March 20, 2015

Re: Foundation Recommendations for Proposed Entrance Structure
Veterans Administration Building - Woodward Avenue, Philadelphia
ARM Project 150210

1 FOUNDATION/BASEMENT PLAN
SCALE: 1/4"=1'-0"

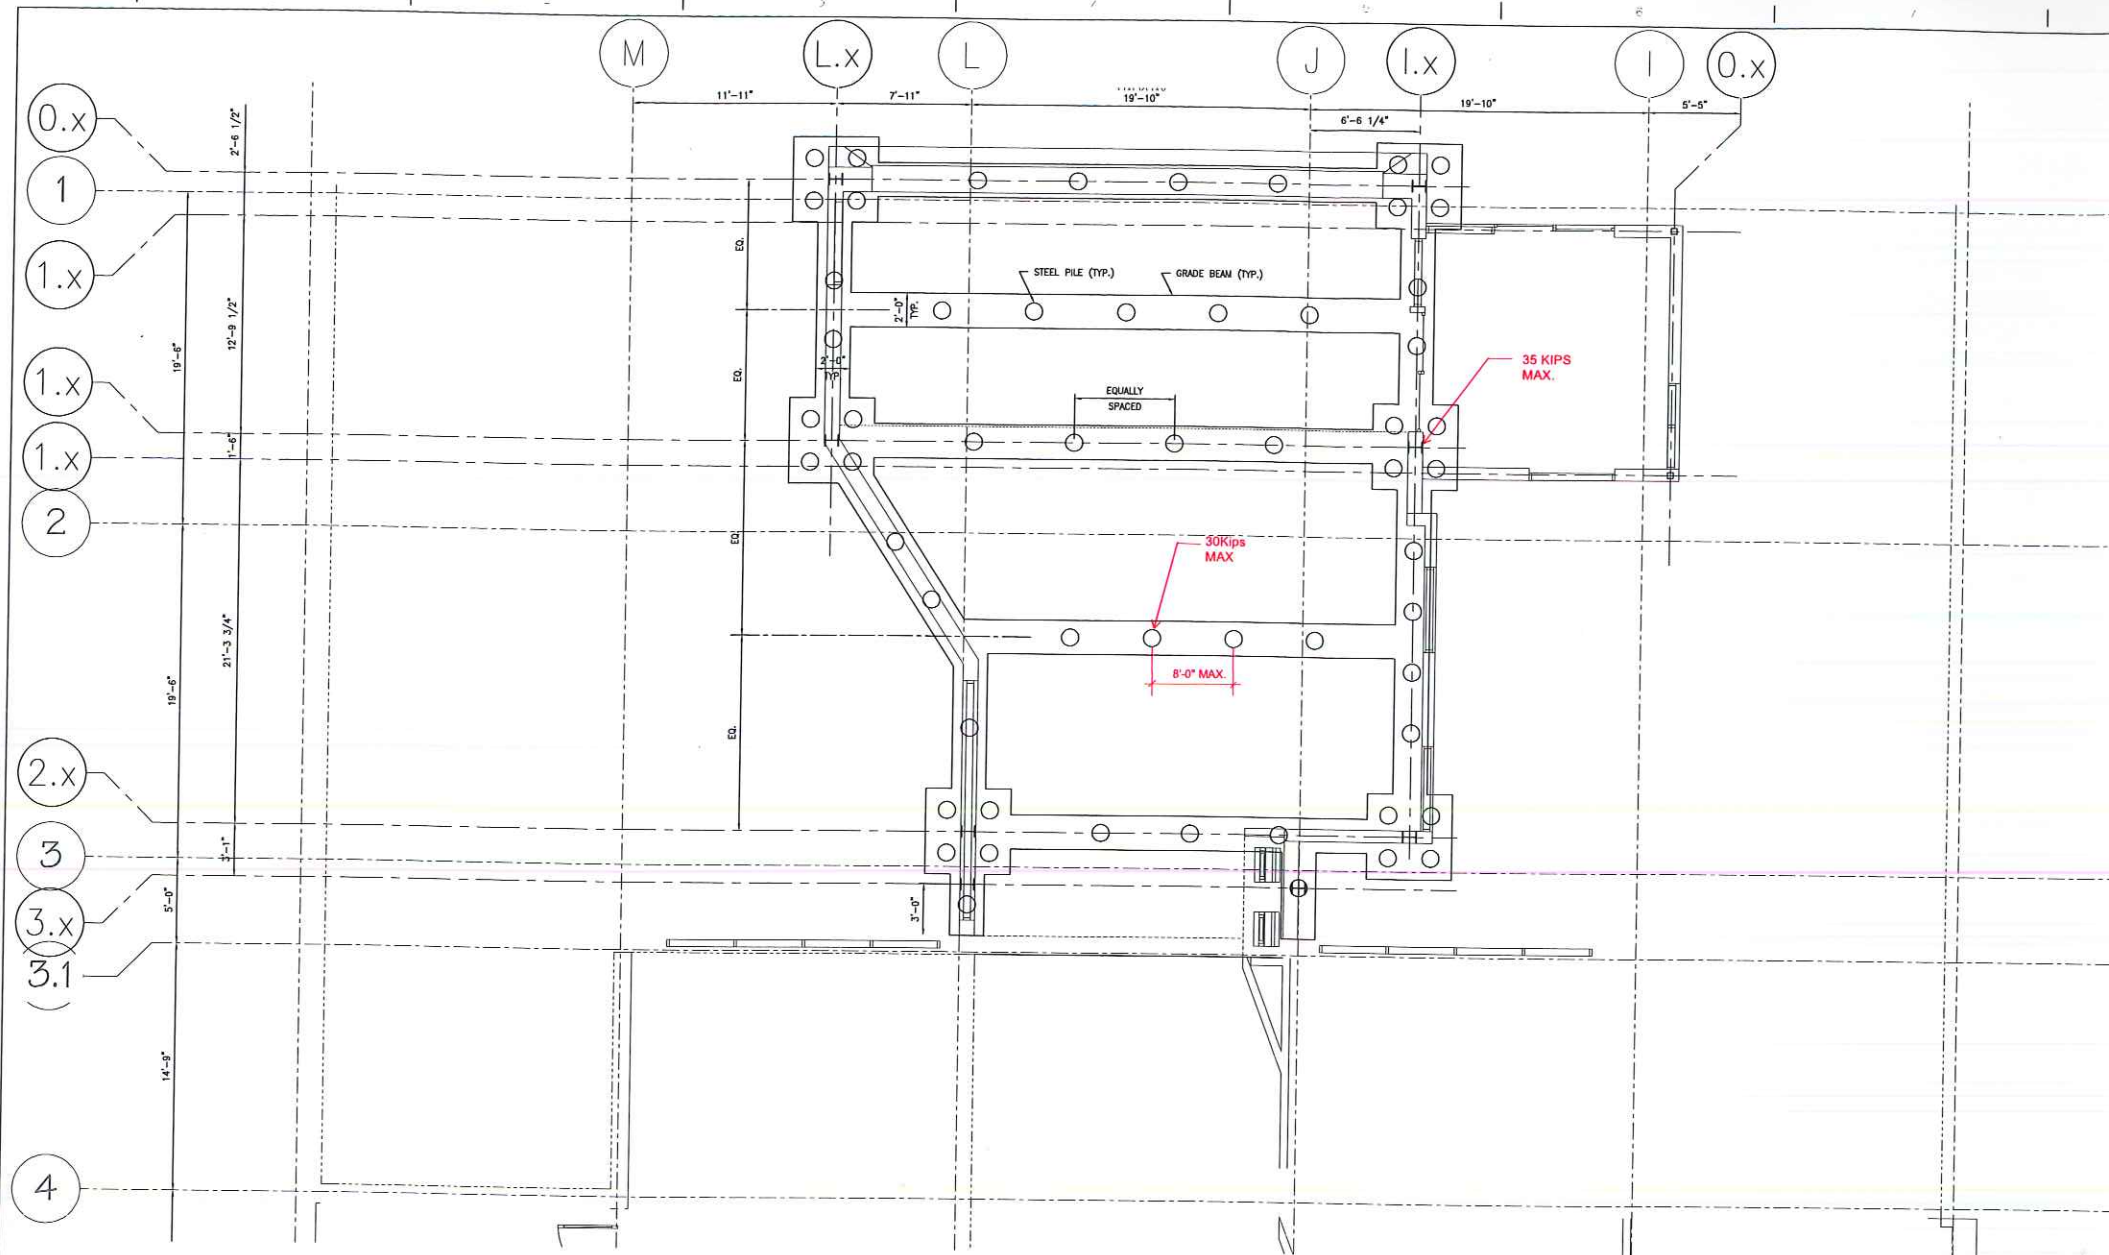
Pursuant to our recent correspondence ARM Group Inc. (ARM) has reviewed subsurface conditions at the entrance location, in concert with consideration of the anticipated foundation loads shown on the attached copy of Drawing Number S-10B. Referring to the attached drawing, the maximum anticipated working load for at any given support point is 35 kips. As you know, ARM performed two exploratory borings at the entrance in February 2012. The conditions encountered, and recommendations for the proposed entrance structure, were presented in ARM's April 11, 2013 report. The locations of the two borings are shown on the attached figure. It is my understanding that final design of the entrance structure was temporarily halted sometime after ARM's report was submitted, and that design has recently resumed.

As a general comment regarding the foundations discussed below, the proposed entrance structure is not a heavy structure, and will impose only modest foundation loads. A maximum working load of only 35 kips is quite low compared to the working loads associated with most structures bearing on deep foundations, and in the case of the entrance structure the maximum working loads are controlled more by the need to maintain a reasonable spacing between adjacent foundation support points than by the weight of the structure itself. It is also noted that the recommendations below do not address tolerances regarding out-of-location or out-of-plumb shafts or piles; it is assumed that Miller-Remick will address the potential for eccentric loads associated with such installation issues.

Concrete-filled drilled shafts bearing within the schist bedrock underlying the site could be used to support the entrance structure. A minimum shaft diameter of 18-inches is recommended to develop a working load of 35 kips, based on an allowable bearing pressure of 20 kips per square foot (ksf) for site bedrock. Drilled shafts should include a minimum rock socket length of 3 feet extending below the point of auger refusal. Auger refusal may be defined in terms of less than 2-inches of advancement per minute using an auger with carbide teeth advanced by a rig generating at least 30,000 foot pounds of torque while exerting a down force of at least 2,000 pounds. Alternately, the point of auger refusal may be determined by the judgement of a field inspector with appropriate experience; or, required tip elevations could be established on the basis of exploratory probes (e.g. small diameter holes advanced by a rotary-percussive drilling rig) performed at each pile or column location during construction.

Steel H-piles driven to end bearing in schist may be designed for an allowable bearing capacity of 6 kips per square inch (ksi) of cross sectional area. The smallest available H-section is the 8 x 36 with a cross sectional area of 10.6 inches, and therefore the 35 kip maximum working load should be readily achievable. Larger piles may be used at the option of Miller-Remick or the contractor. The installation specification should require the contractor to submit a wave equation (WEAP) analysis confirming that the proposed pile hammer can drive the pile to an ultimate capacity correlating to 12 ksi applied to the cross sectional area of the pile without overstressing the pile. The installation specification should note the potential for encountering coarse debris, and the possible need for spudding or similar measures to advance the piles. Piles should be

Pipe piles driven to end bearing in weathered schist should be driven closed end with prefabricated conical tips to enhance drivability through fill materials. A minimum pile diameter of 6-inches is recommended, and a minimum wall thickness of 0.375 inches is recommended to allow for long term corrosion losses. The installation specification should require the contractor to submit a wave equation analysis confirming that the proposed pile hammer can drive the pile to an ultimate capacity correlating to 12 ksi applied to the cross sectional area of the pile without overstressing the pile. The installation specification should note the potential for encountering coarse debris, and the possible need for spudding or similar measures to advance the piles. The piles should be filled with concrete after installation.

Based on the depth to rock at the two borings performed in the entrance area in 2012, it is expected that the foundation elements described above will achieve the required bearing capacities at depths ranging from 35 to 45 feet below existing grade.
